Responses to FCC questions

Re: FCC ID EW780-5348-00

Correspondence Reference Number : 25368

July 10, 2003

1.1 Frame Length

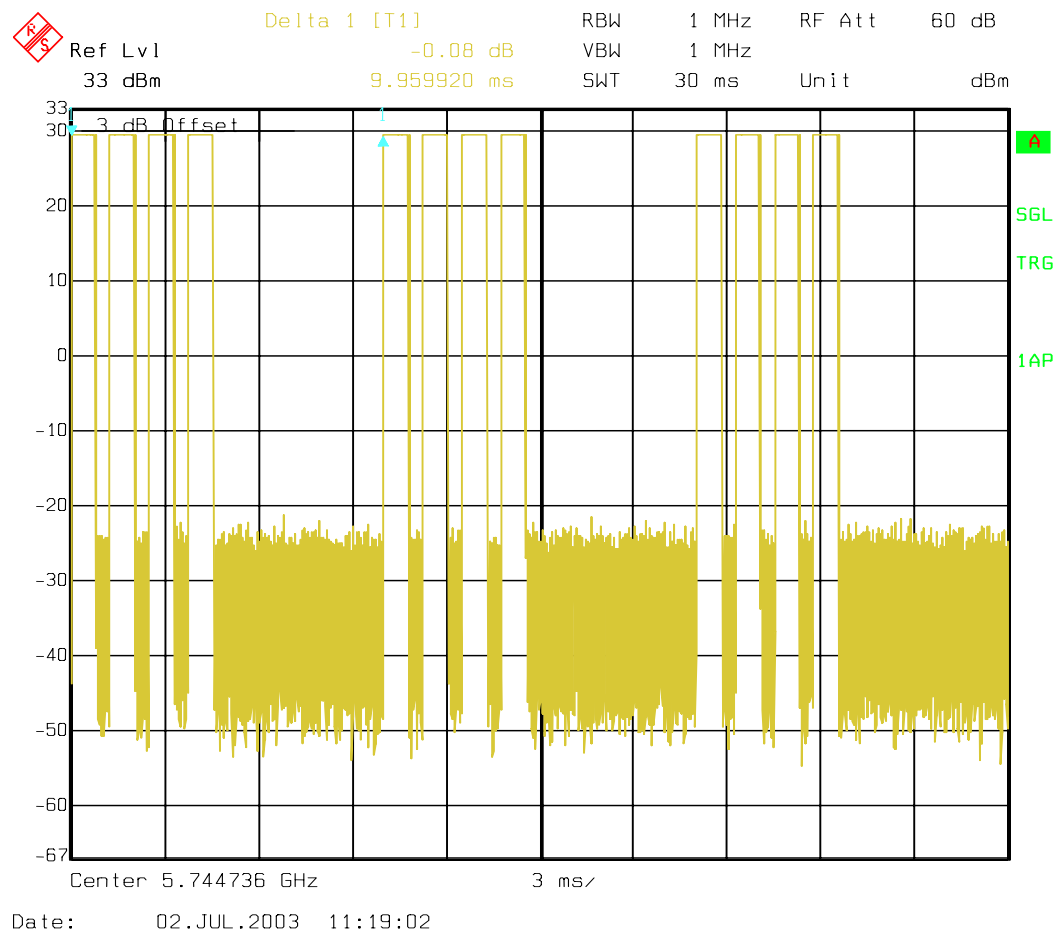
Base Transmit Duty Cycle Calculation for SAR Measurement (Response item 8)

This test is done on a BS transmitter, set into Test Mode with all (4) tx slots active. Note that this is the heaviest the BS transmitter will be used during standard phone operation.

This plot shows the frame length as indicated by the markers: 9.96ms.
